64KZ-II

Manual Addendum

Part No. 023-2017

CROMEMCO 64KZ-II MANUAL ADDENDUM

Figure C: CDOS/COLOR GRAPHICS SYSTEM SWITCH SETTINGS

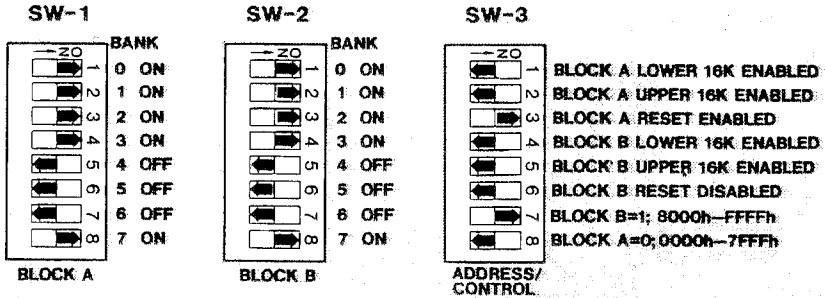
Page 28:

Add the following examples of switch settings for High
Resolution Color Graphics Systems. Set the switches of
additional 64KZ-II boards as shown in the Cromix
Operating System manual for Banks 1, 2, and 3. Note
that SW-3 must be set like SW-1, SW-1 like SW-2, and
SW-2 like SW-3.
